INVERNESS SUBDIVISION, SECOND UNIT, **RESUBDIVISION OF LOTS 36 & 37**

Engineering Comments: FINAL PLAT COMMENTS (should be addressed prior to submitting the FINAL PLAT for review and/or signature by the City Engineer):

APPLICATION NUMBER 4 DATE December 17, 2020

DETAIL SITE PLAN

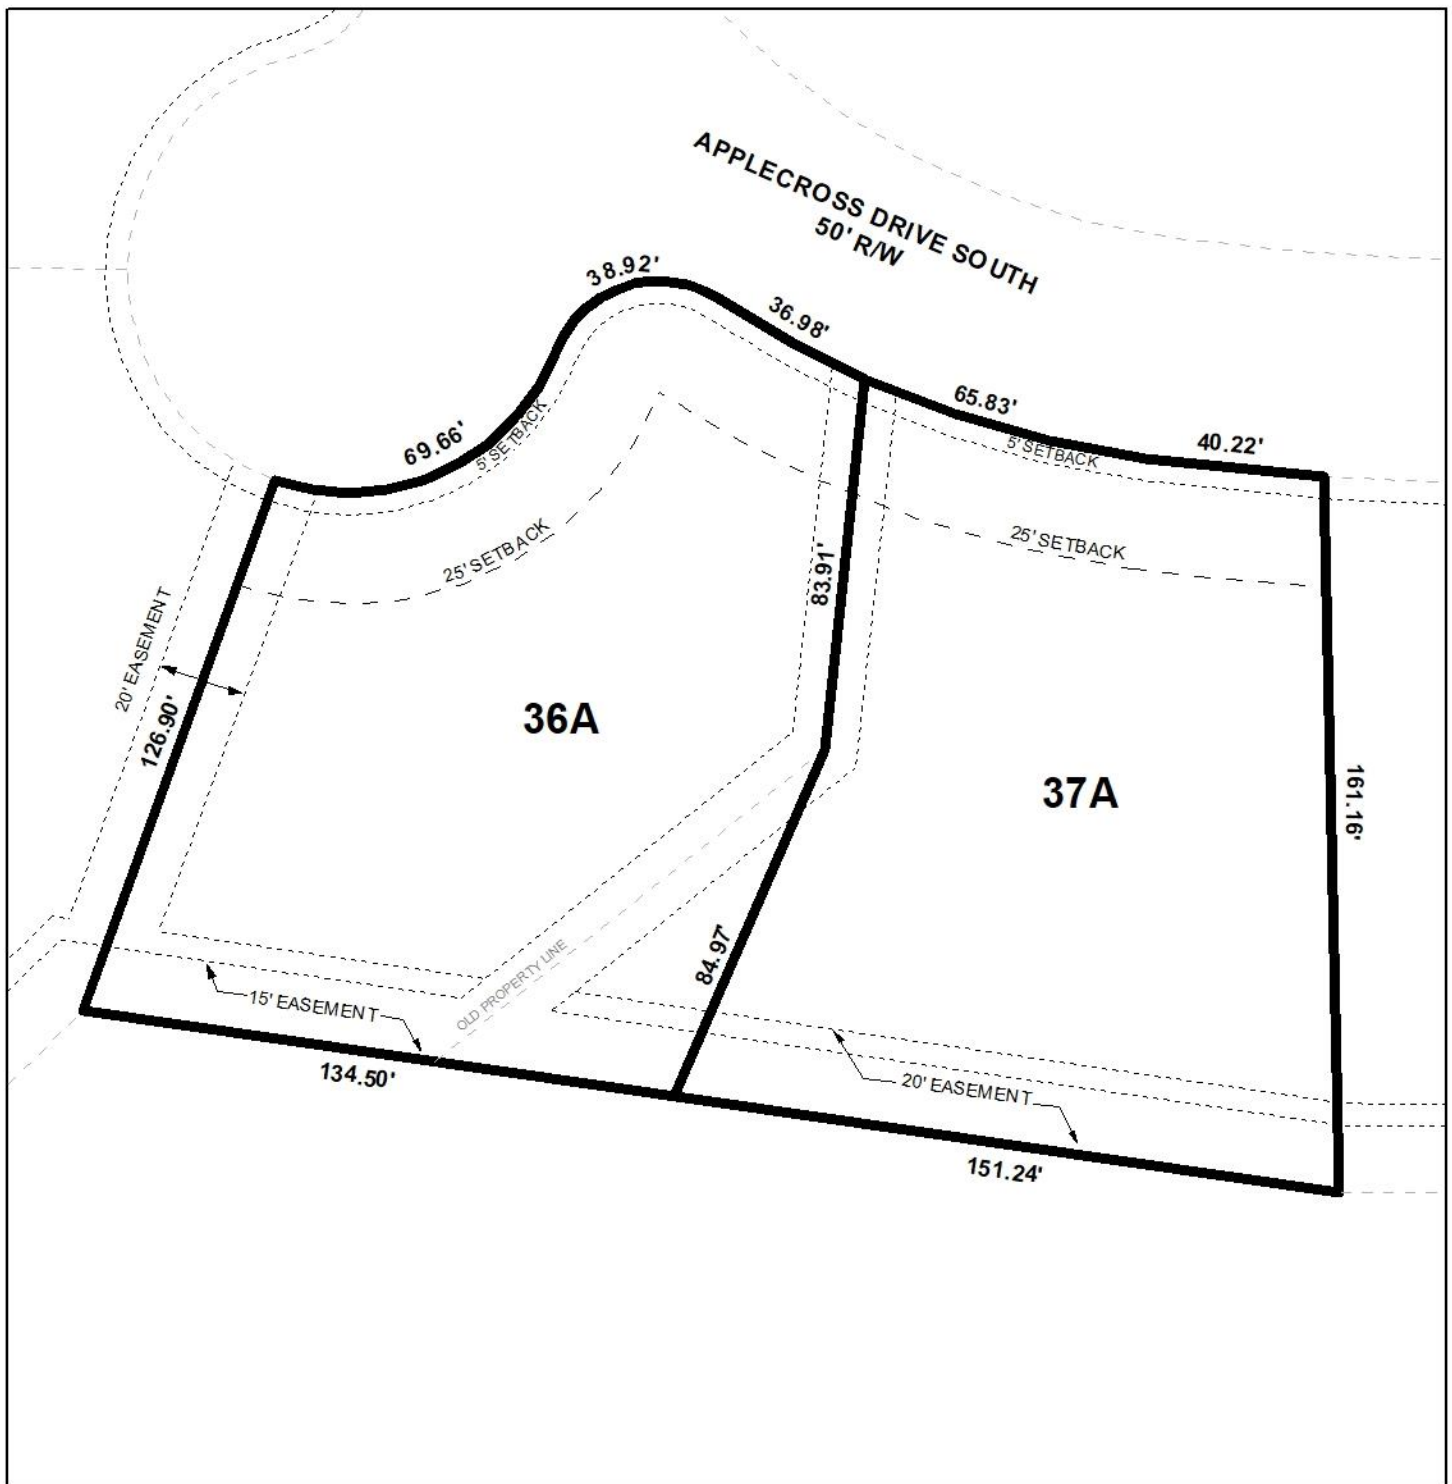
- A. Provide all of the required information on the SUBDIVISION PLAT (i.e. signature blocks, signatures, certification statements, written legal description, required notes, legend, scale, bearings and distances) that is required by the current Alabama State Board of Licensure for Professional Engineers and Land Surveyors.

- B. Add street names to the vicinity map including Apple Cross Dr. S.
- C. Add a signature block for the Traffic Engineering Dept.
- D. Provide the Surveyor's and Owner's (notarized) signatures.

- E. Add a note that a Land Disturbance permit will be required for any land disturbing activity in accordance with Mobile City Code, Chapter 17, Storm Water Management and Flood Control; the City of Mobile, Alabama Flood Plain Management Plan (1984); and, the Rules For Erosion and Sedimentation Control and Storm Water Runoff Control.

- F. Add a note that the approval of all applicable federal, state, and local agencies (including all storm water runoff, wetland and floodplain requirements) will be required prior to the issuance of a Land Disturbance permit.

- G. Add a note that sidewalk is required to be constructed, and/or repaired, along the frontage of each lot, or parcel, at time of new development or construction, unless a sidewalk waiver is approved.

- H. Add a note that all existing and proposed detention facilities, common areas, and wetlands shall be the responsibility of the Property Owner(s), and not the responsibility of the City of Mobile.

- I. Add a note that all easements shall remain in effect until vacated through the proper Vacation process.
- J. Email a pdf copy of the FINAL SUBDIVISION PLAT and LETTER OF DECISION to the Permitting Engineering Dept. for review at land.disturbance@cityofmobile.org prior to obtaining any signatures. No signatures are required on the drawing.

The applicant proposes to shift the common internal property line between the two lots to increase the area of Lot 36 and decrease the area of Lot 37. Both proposed lots meet the minimum size requirements of the Subdivision Regulations.

The site has frontage along Apple Cross Drive South and a cul-de-sac of Apple Cross Drive West. Apple Cross Drive is a minor street with curbs and gutters and a compliant 50' right-of-

way; therefore, no dedication would be required. The adjacent cul-de-sac also has curbs and gutters with a 100' diameter. The current requirement for cul-de-sacs is a 120' diameter; however, as this was recorded with the current 100' diameter, and as all lots are built-out, no dedication would be required. As on the preliminary plat, the 25' minimum building setback line along all street frontages should be retained on the Final Plat. As also illustrated on the preliminary plat, the lot size labels in both square feet and acres should be retained on the Final Plat, or a table should be furnished on the Final Plat providing the same information.

The plat indicates several easements within both proposed lots. As the existing common interior property line bisects an unspecified easement, the shifting of the Southern portion of the property line to the East will place the new property line out of the easement. However, this will not allow any structure expansion or placement within the easement as it will not shift and will remain as originally recorded. Therefore, a note should be required on the Final Plat stating that no structures shall be constructed or placed within any easement without permission of the easement holder.

Based upon the preceding, this application is recommended for Tentative Approval, subject to the following conditions:

- 1) retention of the 25' minimum building setback line along all street frontages;
- 2) retention of the lot size labels in both square feet and acres on the Final Plat, or the furnishing of a table on the Final Plat providing the same information;

- 4) *placement of a note on the Final Plat stating the Traffic Engineering comments: (Driveway number, size, location and design to be approved by Traffic Engineering and conform to AASHTO standards.);*

- 5) *placement of a note on the Final Plat stating that no structures shall be constructed or placed within any easement without permission of the easement holder;*
